PIC16C74B Rev. A Silicon Errata Sheet

The PIC16C74B (Rev. A) parts you have received conform functionally to the Device Data Sheet (DS30605A), except for the anomalies described below.

Figure 1: $\overline{\text{MCLR}}$ External Circuit

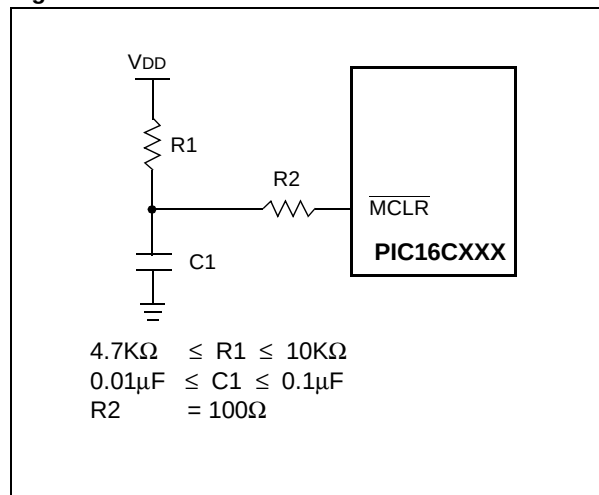
The minimum specification for the $\overline{\text{MCLR}}$ must be met in order to RESET the PIC16CXXX. If a $\overline{\text{MCLR}}$ pulse occurs that is less than the minimum specification (parameter #30), improper device operation can occur.

If the minimum specification cannot be met, then an external circuit must be used to insure that any pulse width less than the specification will be filtered before it reaches the $\overline{\text{MCLR}}$ pin.

A possible circuit is shown in Figure 1. Proper design validation needs to be done to ensure desired operation over the applications operating conditions.

Figure 2: Wake-up from Sleep

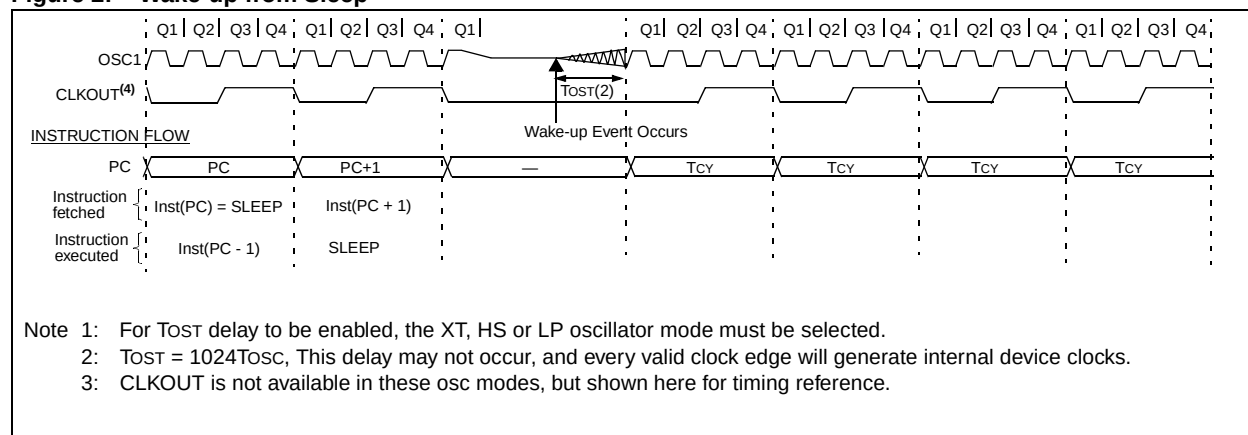
The Oscillator Start-up Timer (T_{OST}) delay may not occur when the device wakes-up from sleep.

Figure 2 shows the start-up of the crystal after the event that causes the device to wake up from sleep mode (as specified in device data sheet). The start-up time (T_{OST}) may not occur.

After the SLEEP instruction, do a software delay of 256 T_{CY} (same as 1024 T_{OSC}). At the Reset and Interrupt vector addresses, test to see if the device woke from sleep (the $\overline{TO}$ and $\overline{PD}$ bits), and if the device did wake from sleep, ensure that the total cycle delay is 256 T_{CY} .

Figure 3: PIC16CXXX Voltage-Frequency Graph

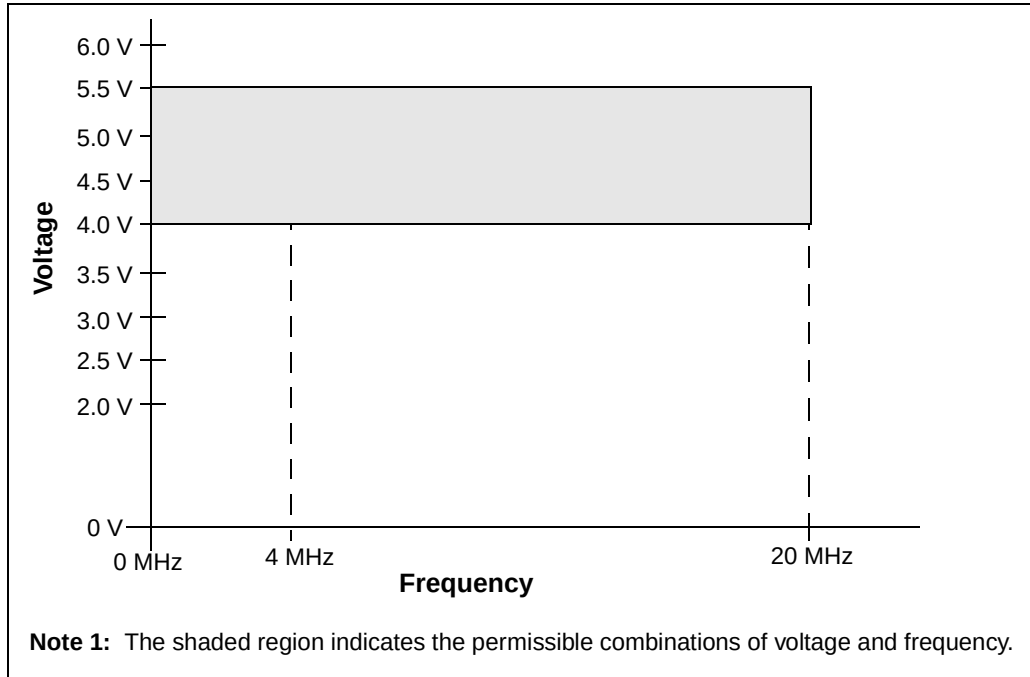
1. Figure 3 and Figure 4 are additions to the data sheet to show the area of operation. These figures replace the Cross Reference of Device Specs for Oscillator Modes Table in the Electrical Specification section.

Figure 3 shows the voltage vs. frequency operation for the PIC16CXXX devices. Devices marked with a "-04" operate up to 4 MHz, while devices marked with a "-20" operate up to 20 MHz. The entire shaded region is the valid operating region.
